**DELAWARE VETERANS MEMORIAL CEMETERY
BEAR, DELAWARE
DE-15-22
BID SET DOCUMENTS**

ADDENDUM NO. 1
June 21, 2016

The attached Sketches, dated 6/4/2016, depict the following described revisions made to the plans as part of Addendum 1:

CG141-SK-2

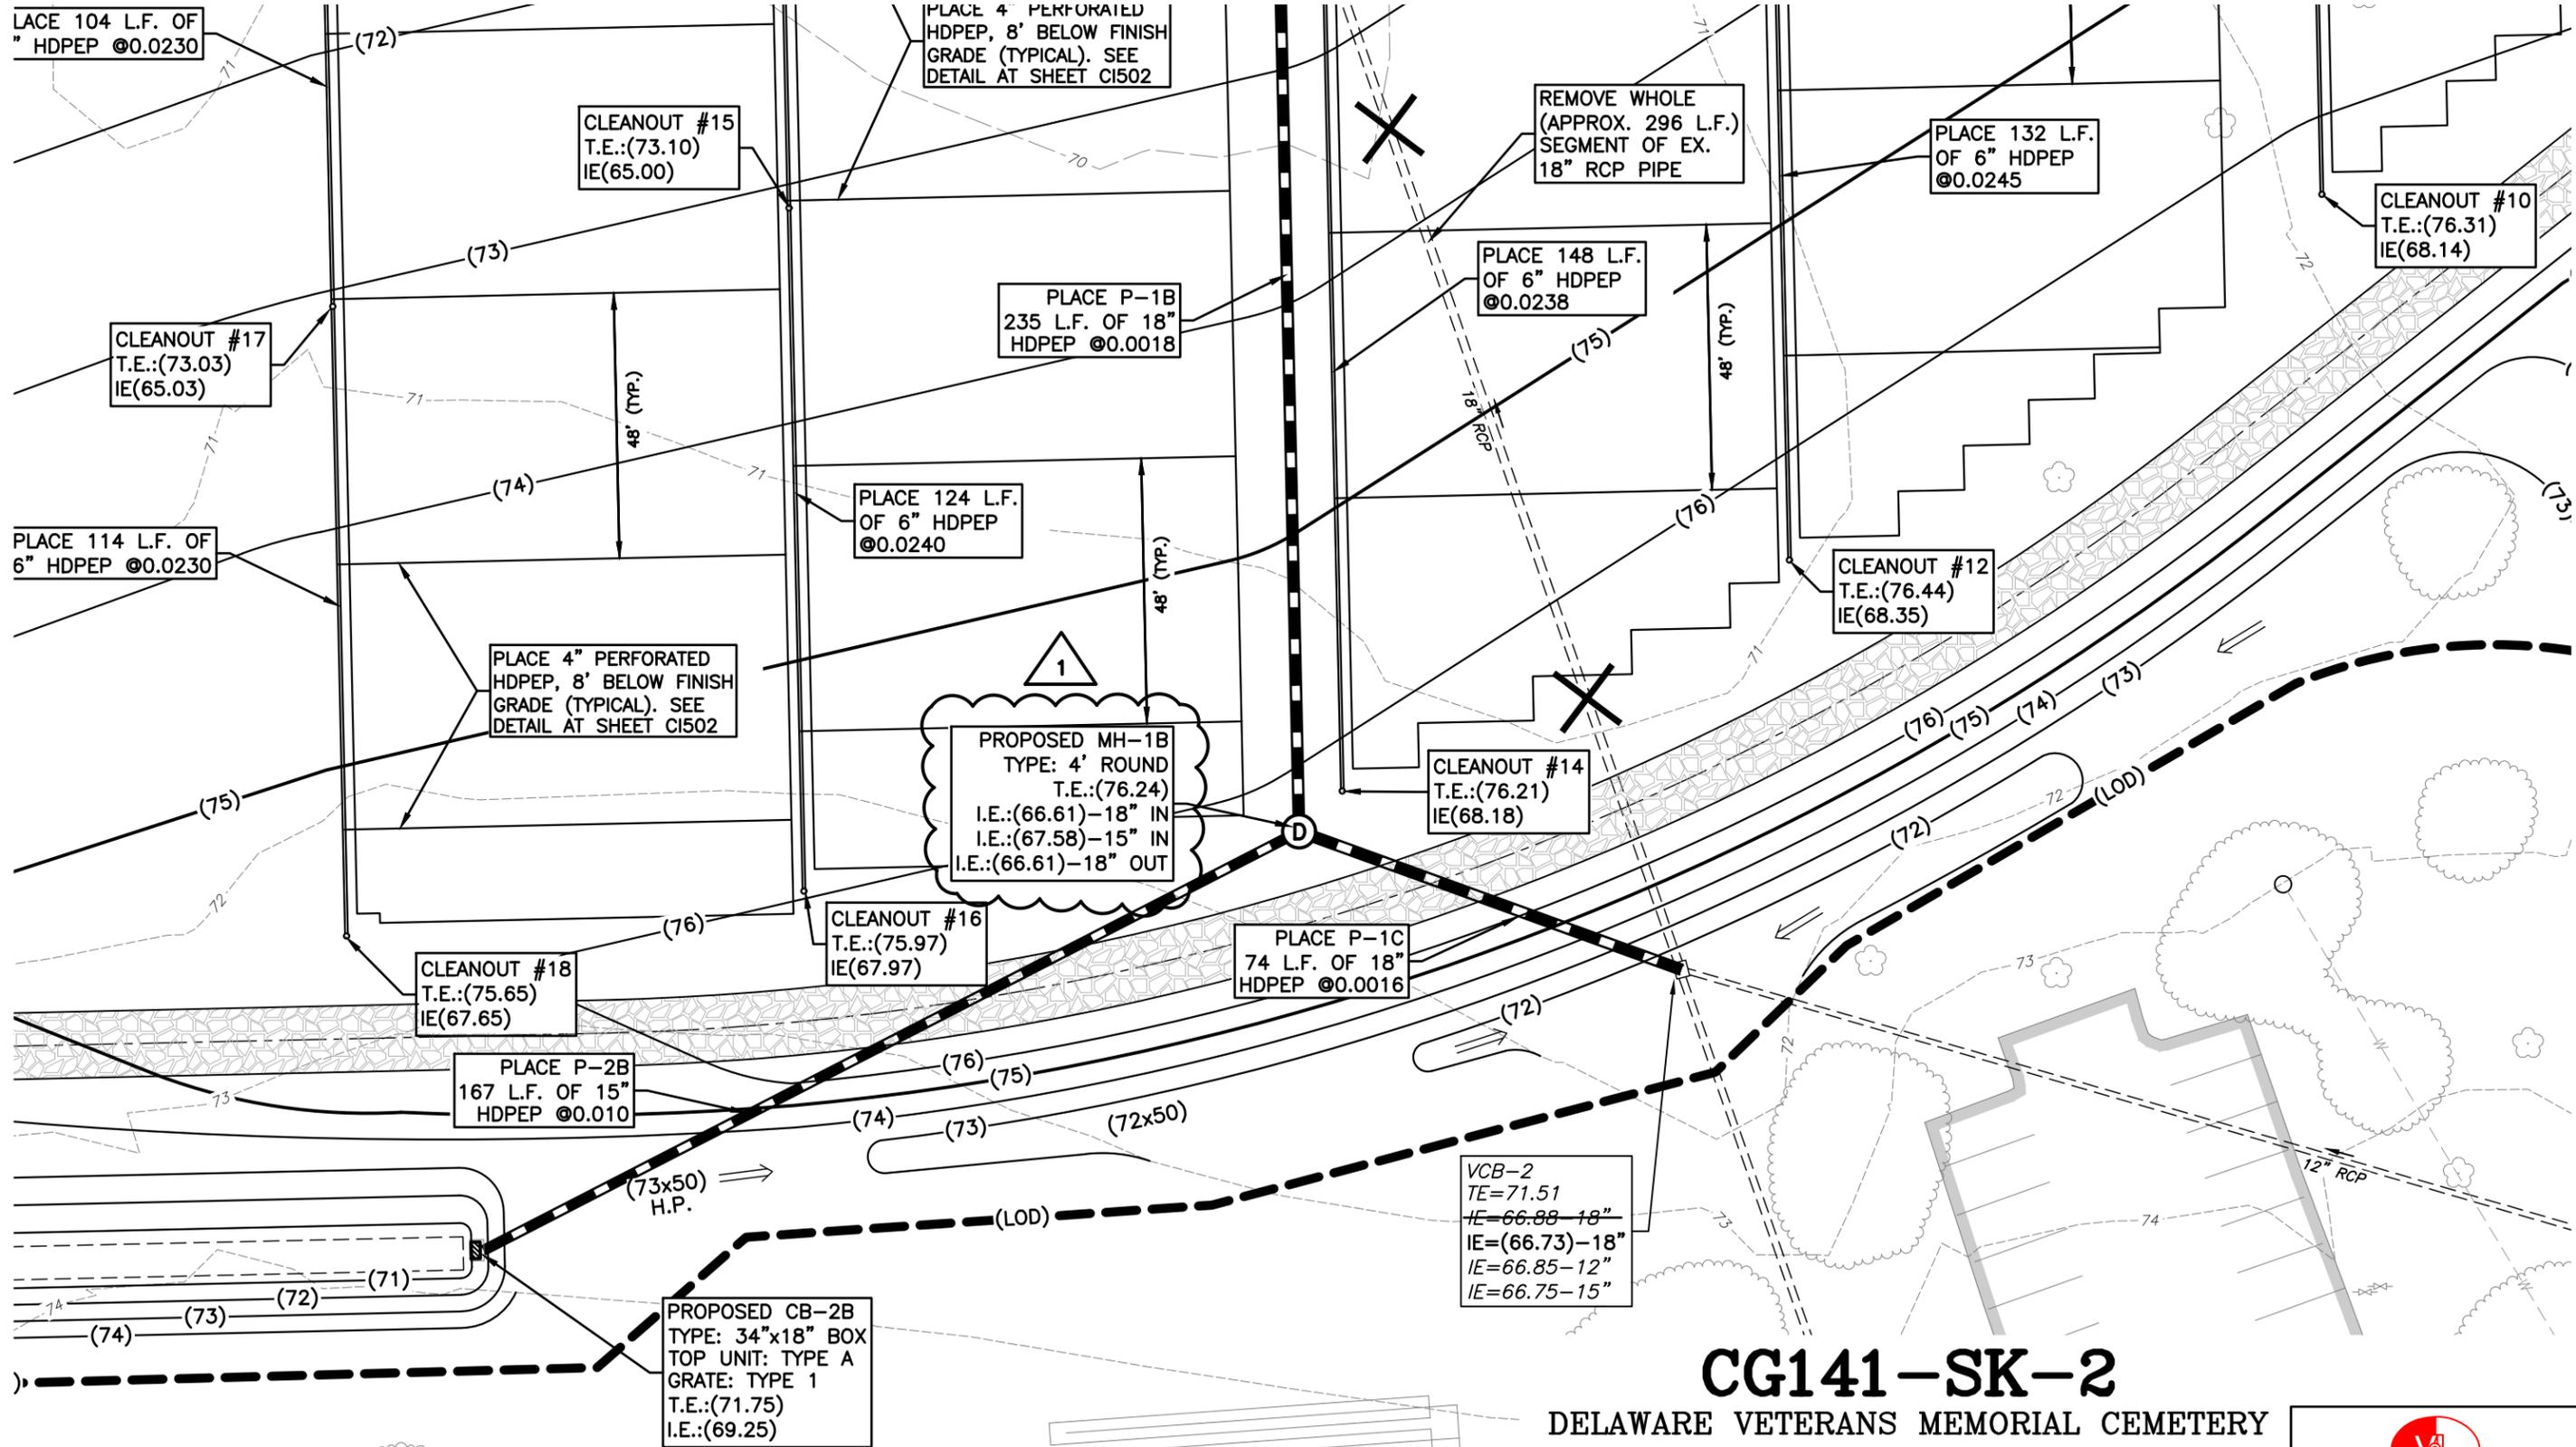
15. CG141-SK-2: Revised manhole top elevation.
16. CG500-SK-1: Revised the design storm elevations note. Added design storm elevation labels to Section B-B.

CG520-SK-2
DELAWARE VETERANS MEMORIAL CEMETERY
BEAR, DELAWARE
DATE: 6/04/2016 PROJECT No.: DE-15-22

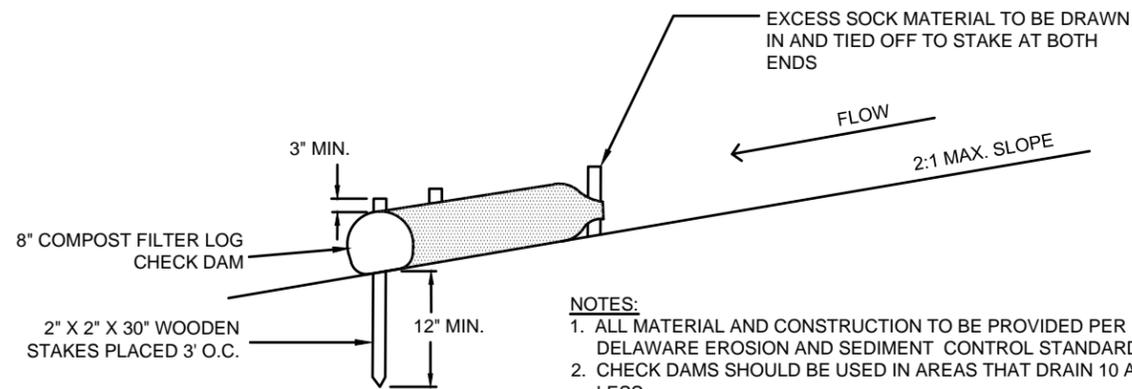
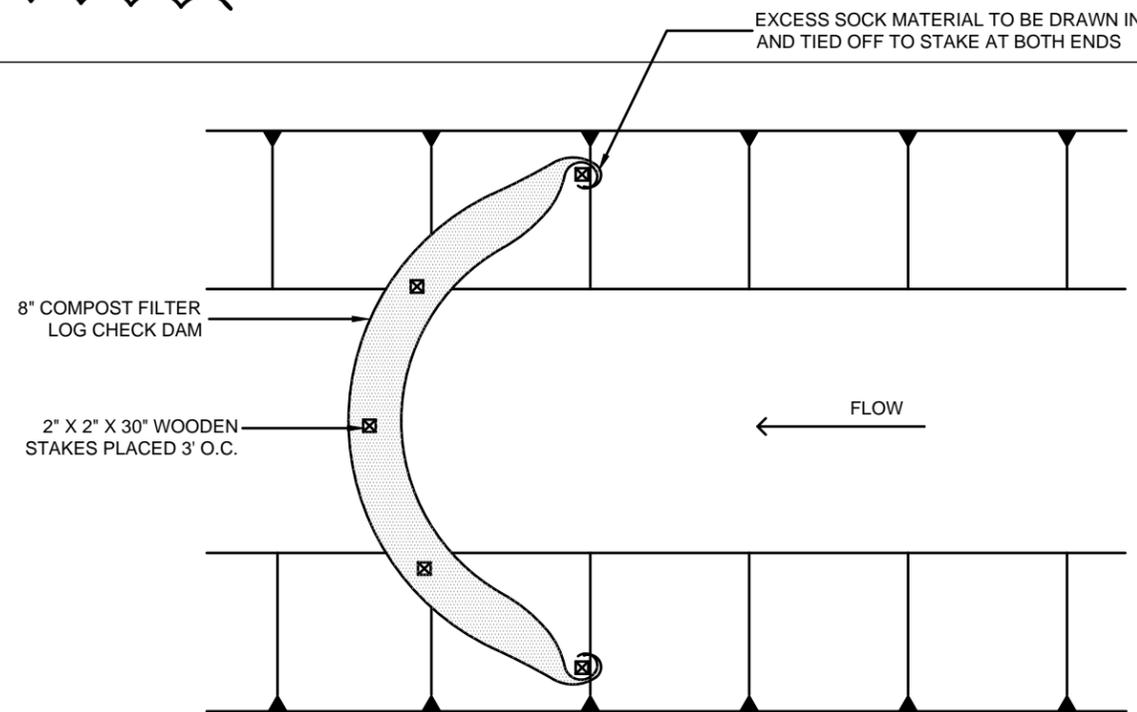
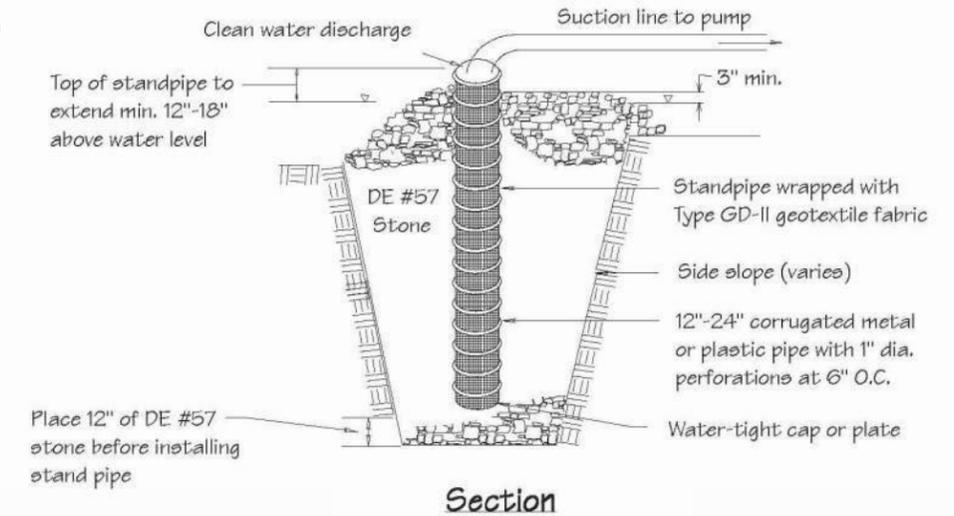
20. CG520-SK-1: Removed Diversion Swale details. Added Temporary Swale details.
21. CG520-SK-2: Removed Stone Check Dam details. Added Vegetated Channel – Parabolic details.

CG520-SK-3

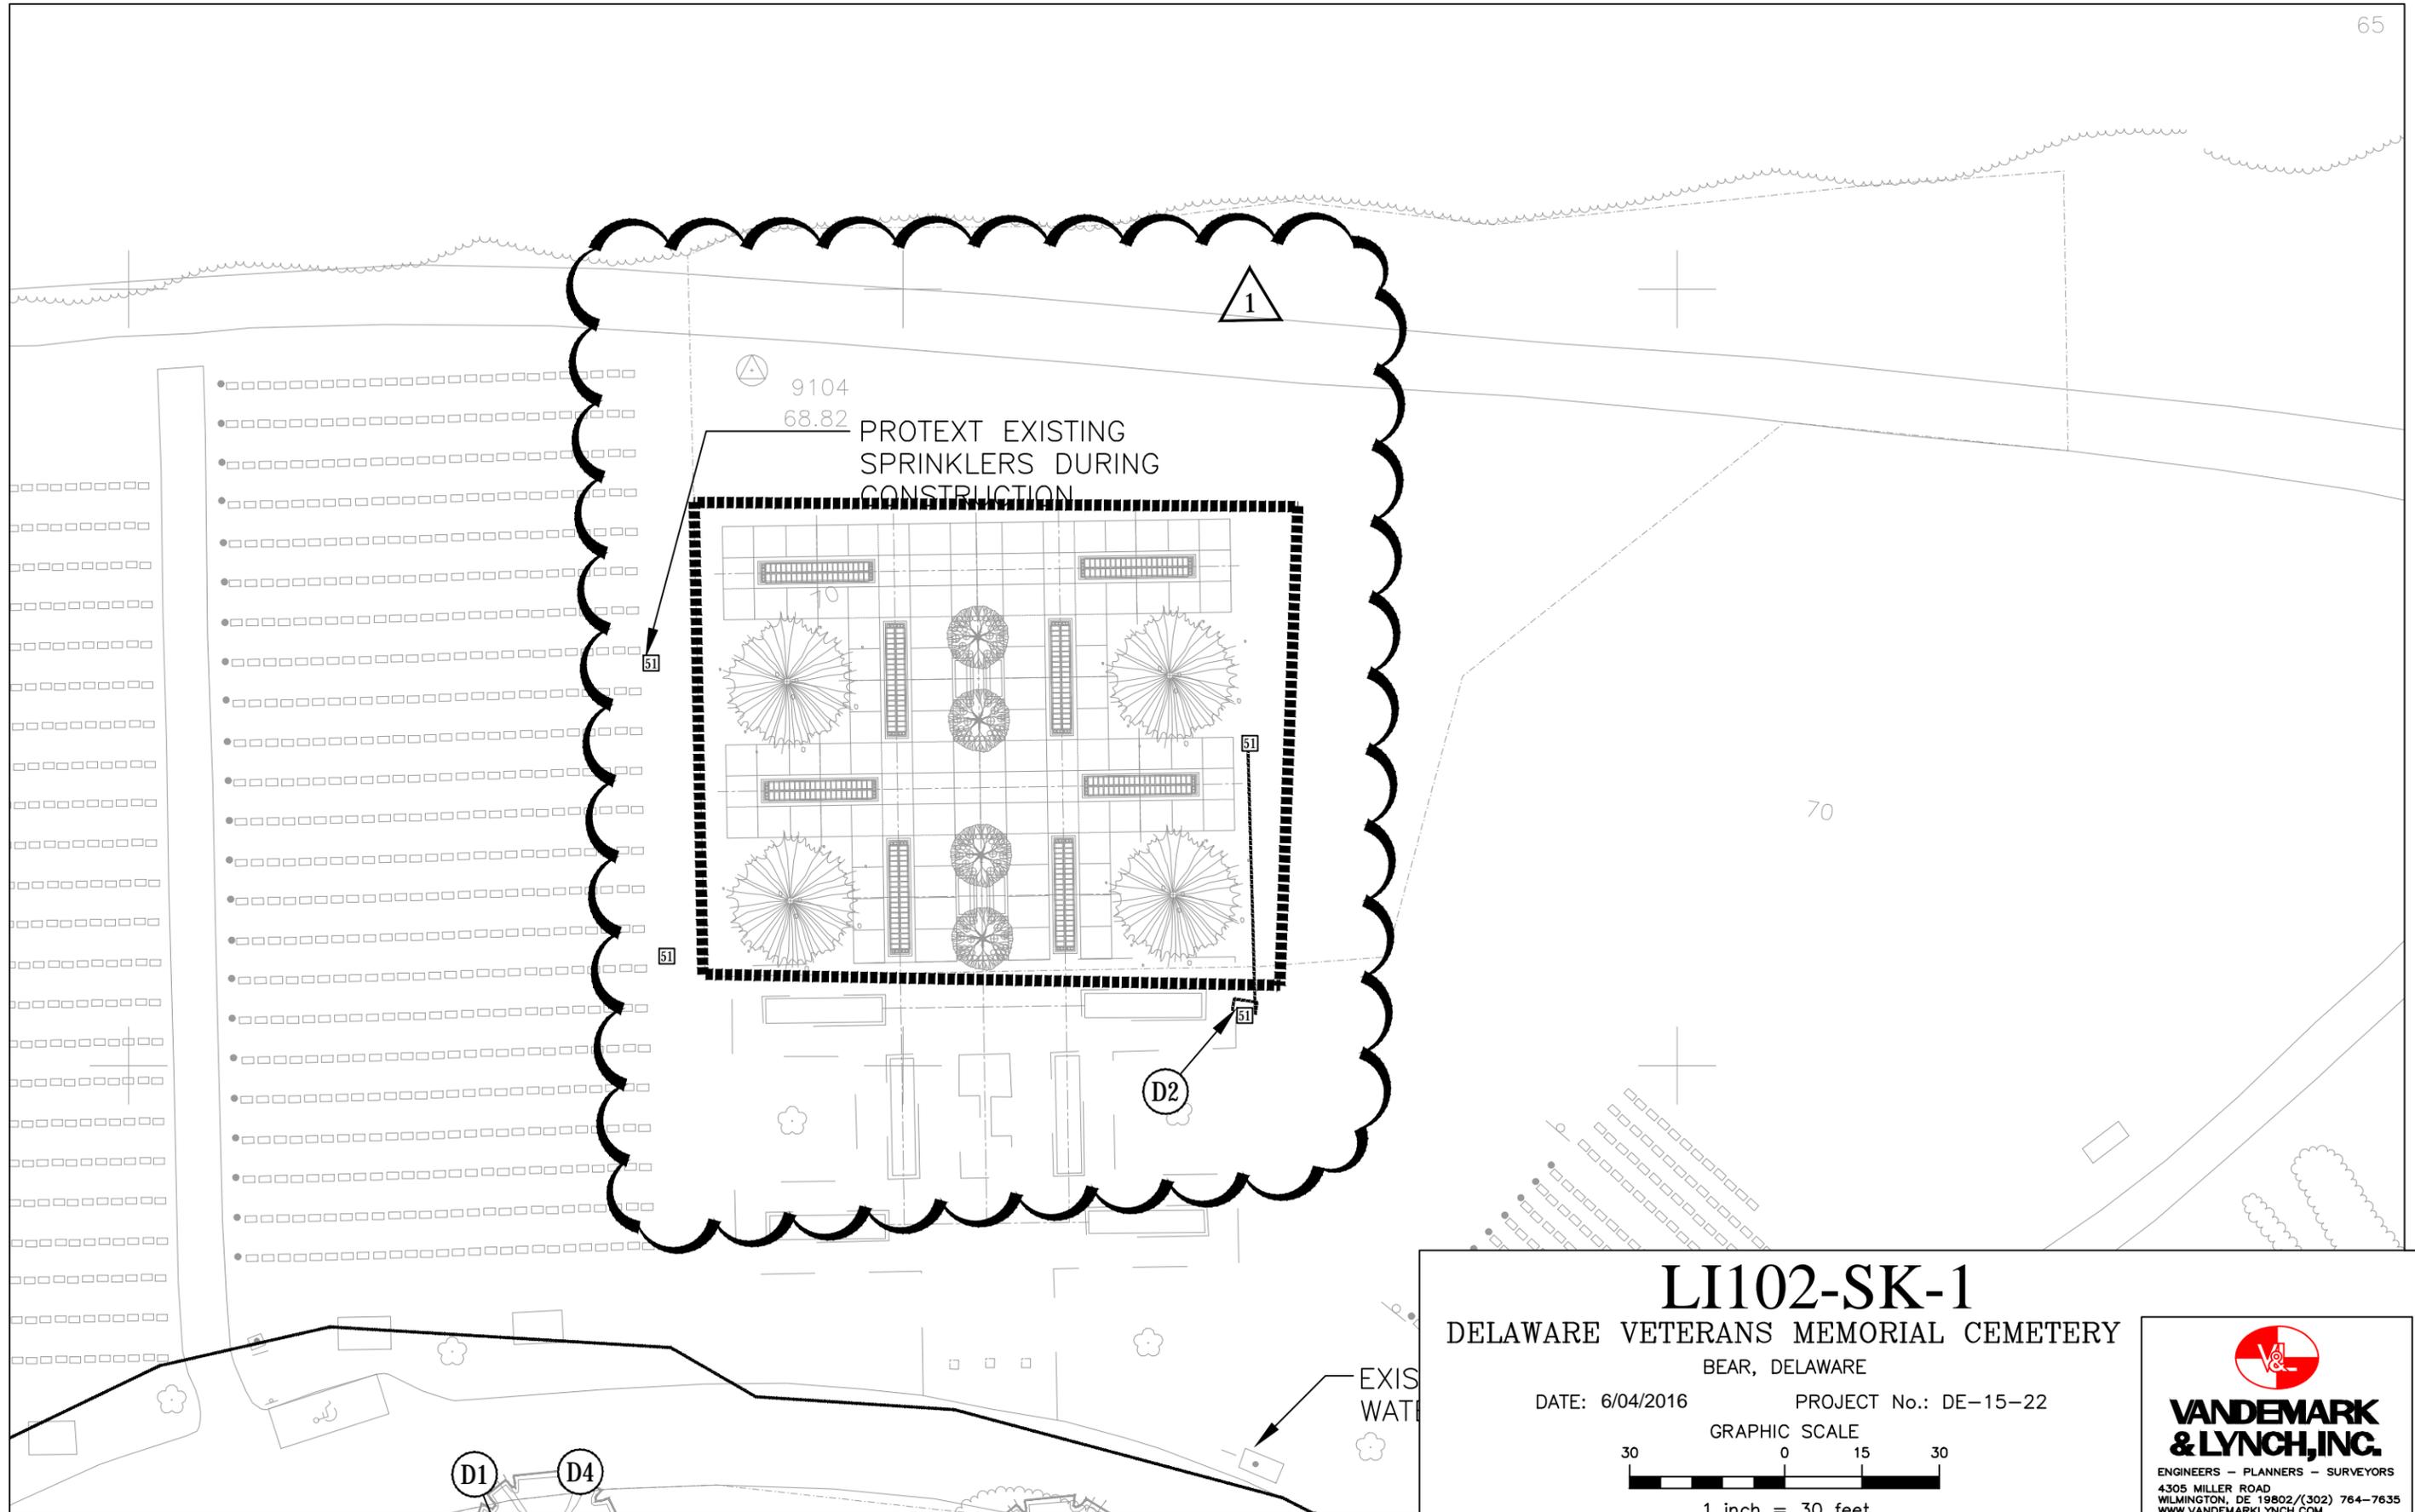
22. CG520-SK-3: Added Compost Filter Log Check Dam detail.
23. CG521-SK-1: Added boxes around recommended temporary and permanent seed mixes.
24. LI102-SK-1: Included existing sprinkler locations adjacent to columbarium. Added callout to protect sprinklers during construction.
